# Cowlitz Indian Tribe

July 26, 2017

RE: Comments Regarding Water Quality Certification for the proposed Millennium Coal Terminal

Figure 6.7-2. Estimated Maximum Annual Coal Deposition—On-Site Alternative

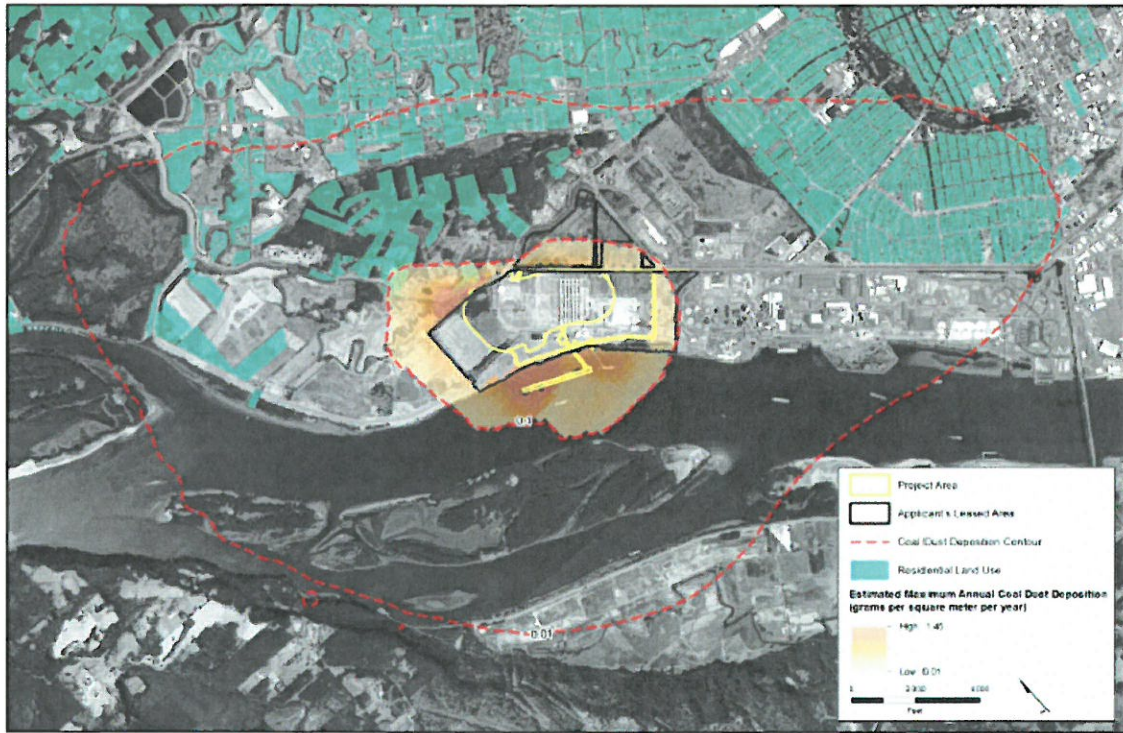
- Coal dust deposition is anticipated to be 1.45 grams per square meter, the highest off-site rate offered by the applicant’s research, in the off-channel slough vicinity. Creation of an off-channel rearing site would create an attractive nuisance in an area likely to become contaminated by coal dust and without

the flushing volume associated with the mainstem Columbia River (see our comment letter dated November 28, 2016 for full associated concerns with coal dust in the Columbia River)

The Millennium Coal Terminal proposed site coal dust deposition modeling illustrates that the heaviest coal dust deposition will occur over the Columbia River. When coal enters the Columbia River, it becomes part of the Columbia River sedimentation process. When it settles to the bottom, it impacts benthic organisms disproportionately. Coal impacts aquatic organisms in ways such as tissue abrasion and smothering or clogging of respiratory and feeding organs. This would have a higher impact on benthic invertebrates and bottom feeding fish, including sturgeon. Further up the food chain, invertebrate community changes could impact fish such as salmon and other higher order species.

Figure 29. Off-Channel Slough Mitigation Site - Planting Plan

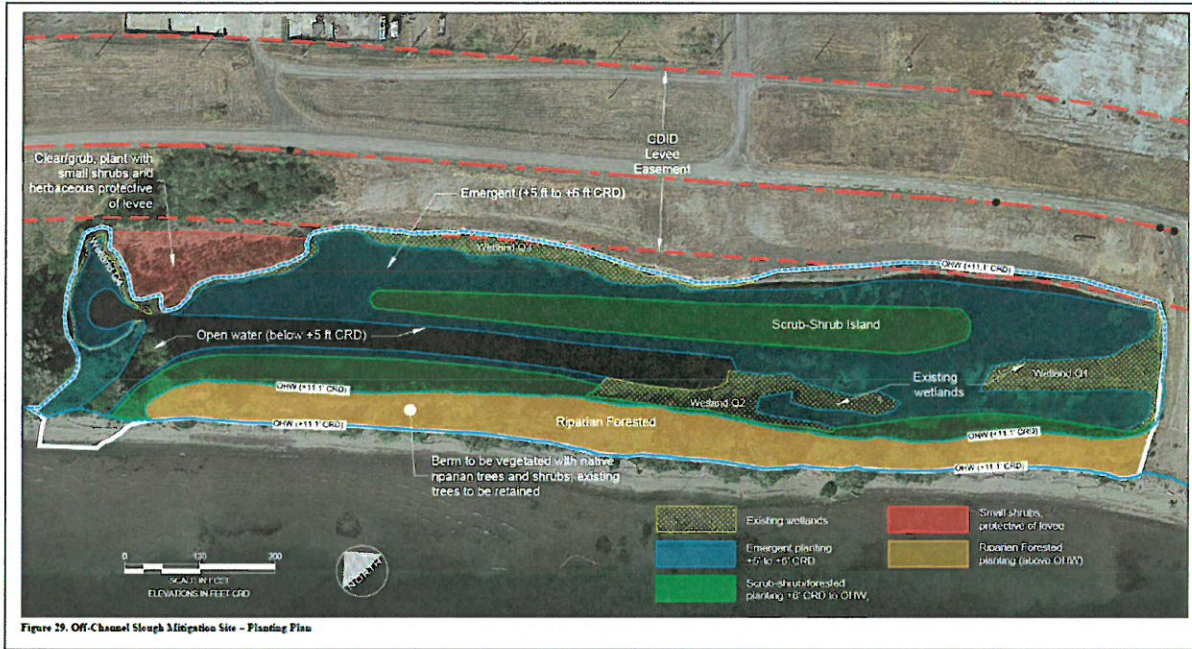
The proposal additionally purports to add 7.4 acres of new aquatic habitat. Reading through the section in detail, it is not until page 113 that an illustration finally makes clear what is proposed. And it is not 7.4 acres. It is a small open water slough with bordering scrub shrub and emergent wetlands. This is described, but not very well, on page 106 as 4.5 acres of native emergent, shrub and tree species. How does an open water area become a small slough? By putting 22,000 cubic yards of 'suitable upland fill' into the existing pond, grading it so it drains out (to reduce fish stranding potential) and then replanting to the emergent and shrub/scrub communities. The pond is currently between 0 and +4 feet in elevation, and after the project, the minimum elevation will be +4.

Millennium Bulk Terminals estimates they will impact 4.83 acres of aquatic habitat. If 7.4 acres of 'new aquatic habitat' subtracts 4.5 acres of wetland and upland enhancement, 3.5 acres of mitigation is proposed. Based on the model below, we suspect that even less aquatic habitat will be permanently created.
